Product Change Notification

Change Notification #: 115118-00
Change Title: Intel® Server System R2208WTTYSR
PCN115118-00, Product Design,
Dimension update on PCIe* riser bracket
holes
Date of Publication: November 22, 2016

Image 1. PCIe bracket holes

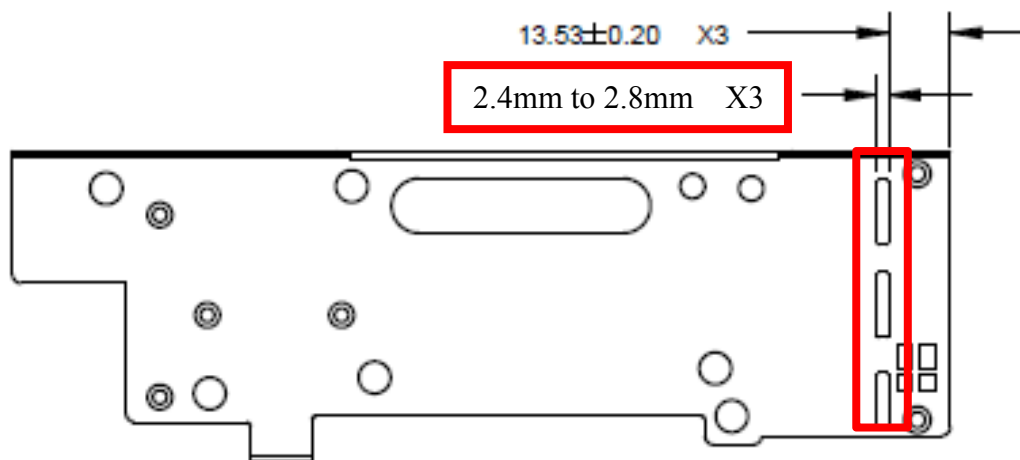
- The width of the holes in the Peripheral Component Interconnect Express (PCIe) Riser bracket change from 2.4mm to 2.8mm. Please see image below for details:

This change will eliminate any difficulty with customers installing PCIe cards in riser 2 and riser 3 on opposing PCIe slots.
